State of New Mexico
Energy, Minerals and Natural Resources

SUNDRY NOTICES AND REPORTS ON WELLS (DO NOT USE THIS FORM FOR PROPOSALS TO DRILL OR TO DEEPEN WELLS BACK TO A DIFFERENT RESERVOIR. USE "APPLICATION FOR PERMIT" (FORM C-101) FOR SUCH PROPOSALS.)	
1. Type of Well: Oil Well <input type="checkbox"/> Gas Well <input checked="" type="checkbox"/> Other <input type="checkbox"/>	
2. Name of Operator Devon Energy Production, LP	
3. Address of Operator 333 W. Sheridan Ave. OKC, OK 73102	
4. Well Location Unit Letter N : 660 feet from the South line and 1980 feet from the West line Section 34 Township 23S Range 33E NMPM Lea, County	
11. Elevation (Show whether DR, RKB, RT, GR, etc.) 3641'

Devon Energy respectfully requests to temporarily abandon the Thistle Unit 4 for five years due on-going evaluation and decision on remediation. Proposed TA procedure below. Please see attached wellbore schematic.

PROPOSED TA WELLBORE

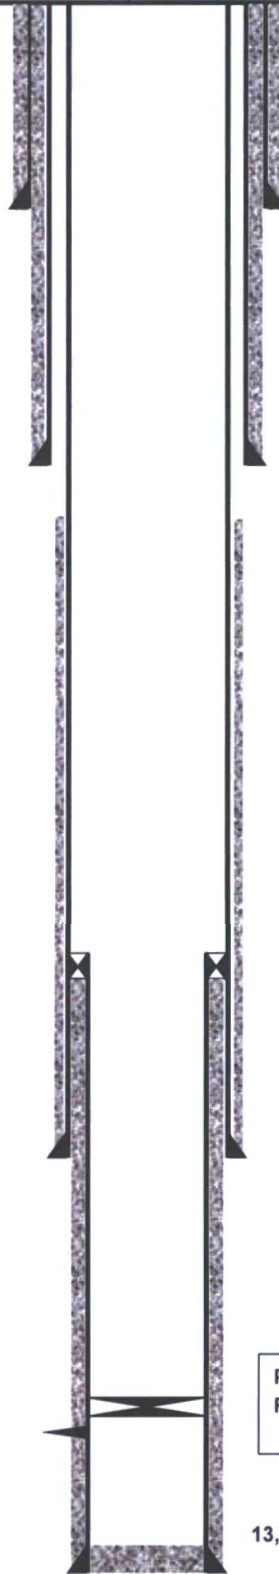
1. POOH W/2-3/8 prod tubing/packer assembly.
2. Set RBP within 100' of top perforation.
3. Circulate wellbore w/field ^{FRESH WATER} brine & corrosion inhibitor.
4. Test casing to 500 psi for 30 minutes (chart record) and have OCD witness.
5. Shut in well.
